Access Compliance Report

Public Rights-of-Way

(Curb Ramps)

Intersection ID: 13667	Main Street: E_7TH_ST	Cross Street: HAWTHORNE_LN	Location: W
ADA ID: C80823D6466F	Ramp Type: Perp	Initial Pass/Fail: Fail	Overall Compliance: No
		Severity Score: 12.5

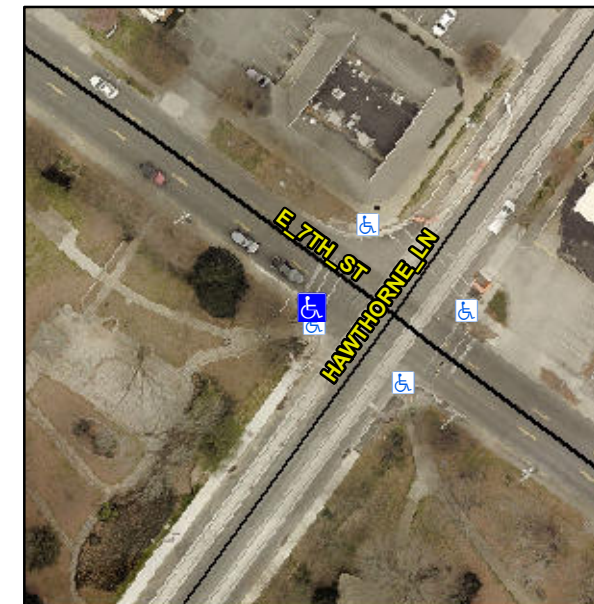
Not Found, R304.2.2

Compliance	Description	Data	Compliance	Description	Data
N/A	Ramp Length (in)	72.0	No	Ramp Slope (%)	9.1
Yes	Ramp Width (in)	48.0	Yes	Ramp XSlope (%)	1.0
N/A	Flare Type LT	N/A	N/A	Flare Type RT	N/A
N/A	Flare Slope LT (%)	N/A	N/A	Flare Slope RT (%)	N/A
N/A	Flare Traversable LT?	N/A	N/A	Flare Traversable RT?	N/A
N/A	Landing Length (in)	N/A	N/A	DWS Provided?	N/A
N/A	Landing Width (in)	N/A	N/A	DWS Contrast?	N/A
N/A	Landing Slope (%)	N/A	N/A	DWS Length (in)	N/A
N/A	Landing X Slope (%)	N/A	N/A	DWS Full Width?	N/A
N/A	Landing Curb? (Y/N)	N/A	N/A	DWS Offset (in)	N/A
N/A	Shared Landing?	N/A			
N/A	Gutter Ponding?	N/A	N/A	Gutter Slope (%)	N/A
N/A	Gutter Lip Ht (in)	N/A	N/A	Gutter X Slope (%)	N/A
N/A	Painted X Walk1?	Yes	N/A	Painted X Walk2?	N/A
	X Walk 1 Direction	To NE		X Walk 2 Direction	N/A
N/A	X Walk 1 Width (in)	110.0	N/A	X Walk 2 Width (in)	N/A
	X Walk 1 Slope (%)	1.6		X Walk 2 Slope (%)	N/A
	X Walk 1 X Slope (%)	1.1		X Walk 2 X Slope (%)	N/A

Remove & Replace Entire Ramp.
